STATE OF RHODE ISLAND & PROVIDENCE PLANTATIONS
EXECUTIVE CHAMBER
PROVIDENCE

January 14, 1981

Mr. Boyce Grier, Director
Region I
U.S. Nuclear Regulatory Commission
631 Park Avenue
King of Prussia, PA 19406

I am enclosing for your information and consideration a variety of documents in response to questions raised by NRC and also in support of requests the State of Rhode Island has already or is herein making to NRC with regard to decommissioning of the UNC Recovery Systems plant in Wood River Junction.

SNM 777 docket 70-6
Sketch No. 721.11-1
By KAH date JAN-1

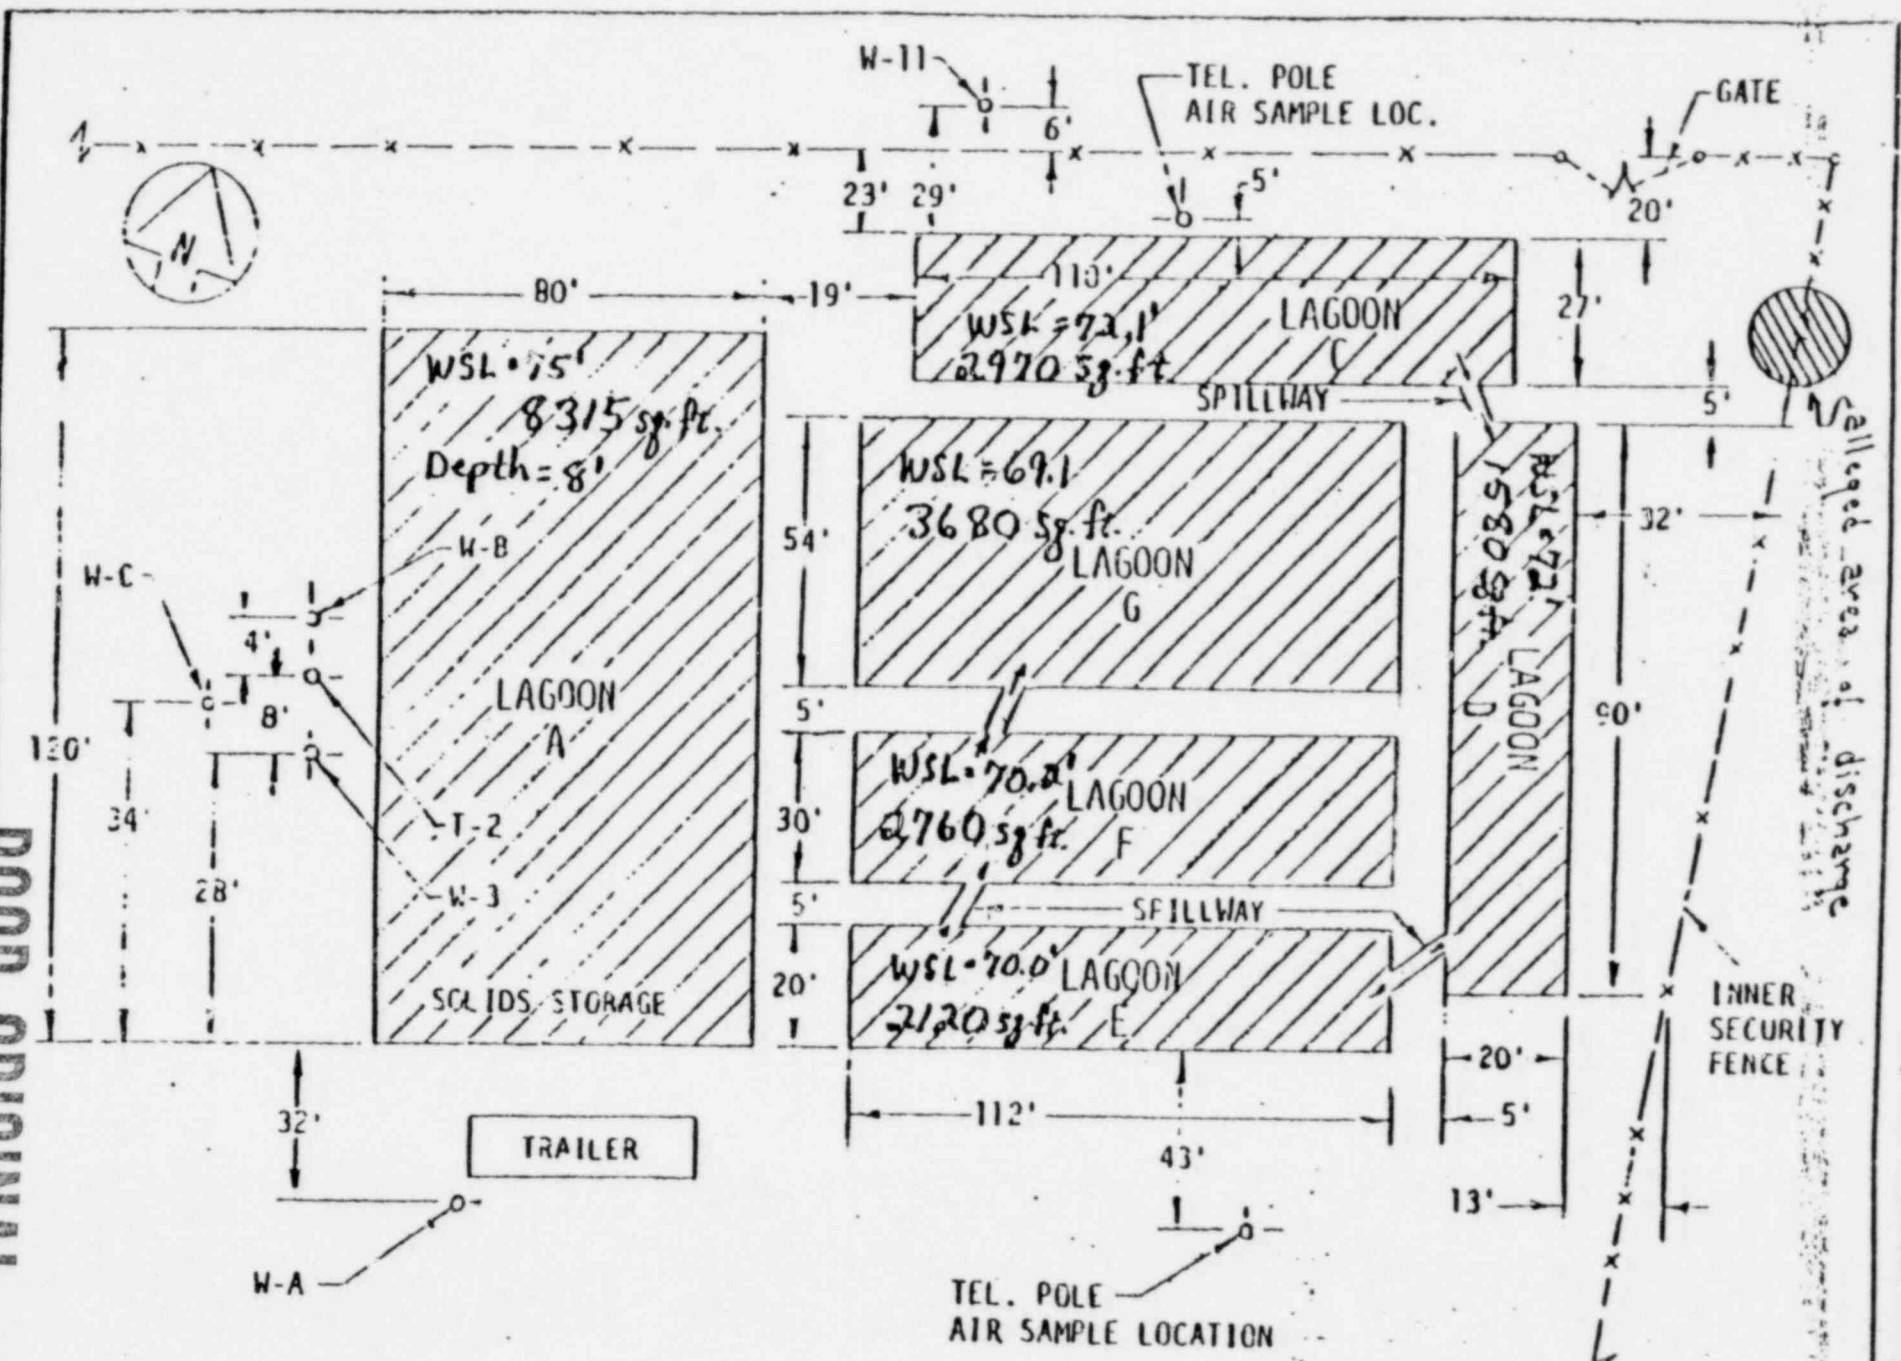
There has been an allegation that the United Nuclear Corporation on one occasion intentionally decanted wastewater lagoon contents to the ground's surface at a point approximately thirty feet south of the north corner of the inner east fence (indicated by a cross-hatched circle on the accompanying map of the wastewater lagoon system).

To substantiate or deny this allegation this office suggests that the U.S. Nuclear Regulatory Commission be requested to collect soil samples both within and outside the area of discharge and analyze these soil samples for constituents likely to be found in the wastewater lagoons. The sampling and testing procedure this office recommends have been attached herein.
